## REQUEST FOR COUNCIL ACTION

AGENDA SECTION: PUBLIC HEARINGS	ORIGINATING DEPT: PLANNING	ITEM NO. <b>E-12</b>
ITEM DESCRIPTION: Preliminary Plat #02-65 by Bigelow Enterprises to be known as Kingsbury Hills Fifth.		PREPARED BY: Mitzi A. Baker, Senior Planner

**RE: Preliminary Plat # 02-65, to be known as Kingsbury Hills Fifth Subdivision, by Bigelow & Sons Enterprises. The plat contains 2.69 acres to be subdivided into 11 single-family home lots. The property is located southerly of and adjacent to the SE corner of Kingsbury Hills Subdivision and east of the present dedicated right-of-way for 51<sup>st</sup> Street NW in Kingsbury Hills Third Subdivision.**

## PRELIMINARY PLAT

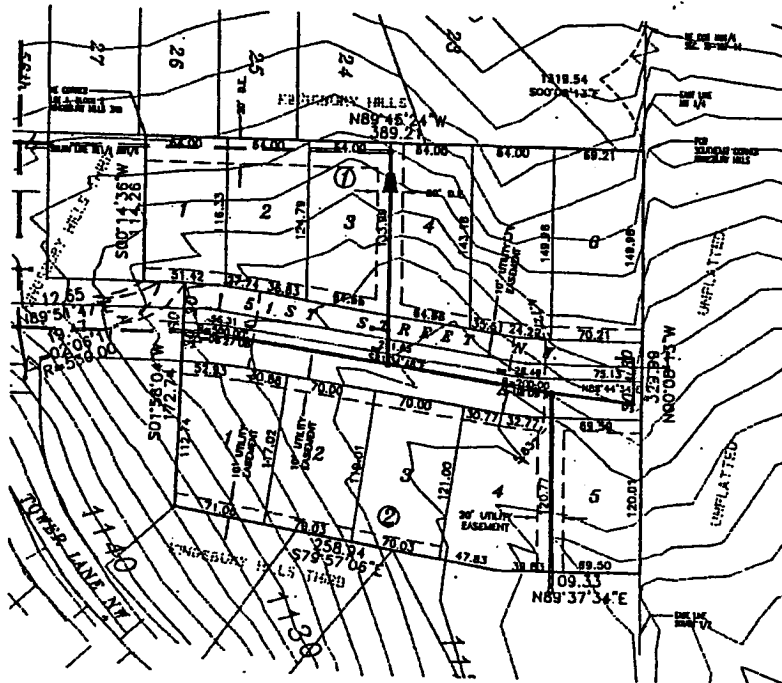
1. ***Storm water management must be provided, and a storm water management fee will apply to any areas of this proposed development that participate in the City's Storm Water Management Plan, and do not drain to an existing on-site detention facility.***

2. ***Off site easements are required for the storm water discharge to areas outside of this subdivision, and for proposed sanitary sewer and watermain that extend beyond the plat boundaries.***

3. ***Parkland dedication requirements shall be met via: cash in lieu of land, per the December 31, 2002 memorandum from Rochester Park and Recreation.***

4. ***Adequate public facilities are not currently in place to serve this proposed development. The timing for development of this subdivision is dependant on the extension of Trunkline Sanitary Sewer to provide gravity service. The timing of construction, and financial obligations of the Owner, shall be addressed for the infrastructure that is needed to meet the "Adequate Public Facilities" requirement in the LDM, prior to Final Plat approval.***

5. ***Prior to development, a temporary turn around and applicable easement is required at the easterly extent of 51<sup>st</sup> St. NW.***

7. A temporary turn around, and applicable easement is required at the easterly extent of 51<sup>st</sup> St NW.
8. Execution of a drainage easement from the adjacent Owner is required to point discharge stormwater between Lots 4 & 5, Block 2.

1. Static water pressures within this area will range from 57 to 66 PSI.
2. Minor revisions to the proposed water system layout are required. We have provided the applicant's engineering firm with these comments.

11. Hydrant spacing identified on the preliminary plat is inadequate. Additional hydrants, meeting the requirements shall be provided with the final construction plans.
